A d d e n d u m

Iowa Department of Transportation
Office of Contracts

B.O.	Proposal ID	Proposal Work Type	County	Project Number	Addendum
164	84-0181-079	HMA Paved Shoulder - New	Sioux	HSIPX-018-1(79)--3L-84	18sep164.a01

RETROFIT THRIE-BEAM
BRIDGE RAIL

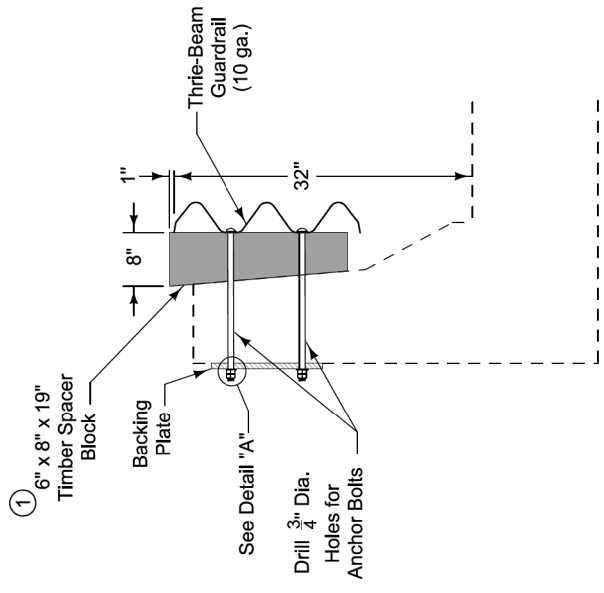
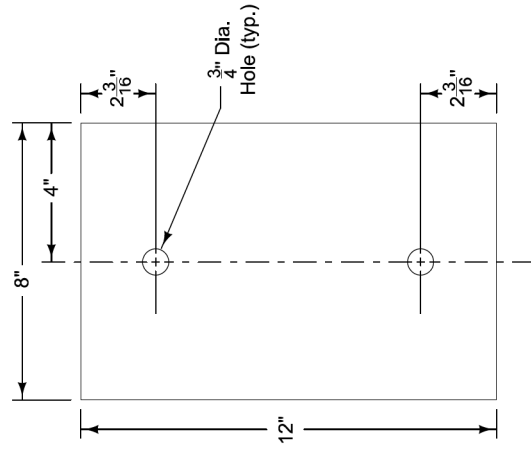
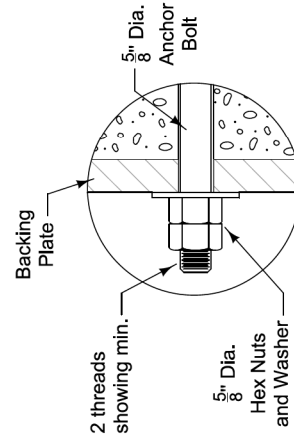
Add the attached plan sheet U.1

Drill holes in existing bridge parapet with a core bit.
Lap guardrail splices in the direction of adjacent traffic.
Use materials meeting the requirements of Section 4155.

Item includes:
Thrie-Beam Guardrail (10 ga.)
6" x 8" x 19" Timber Spacer Blocks
Backing Plates
5/8" x sufficient length Anchor Bolts
5/8" Washers and Nuts

- ① Treated timber blocks meeting the requirements of Section 4164. Ensure guardrail is plumb by trimming back side of blocks to match slope of bridge parapet. Install blocks so that wood grain is vertical.
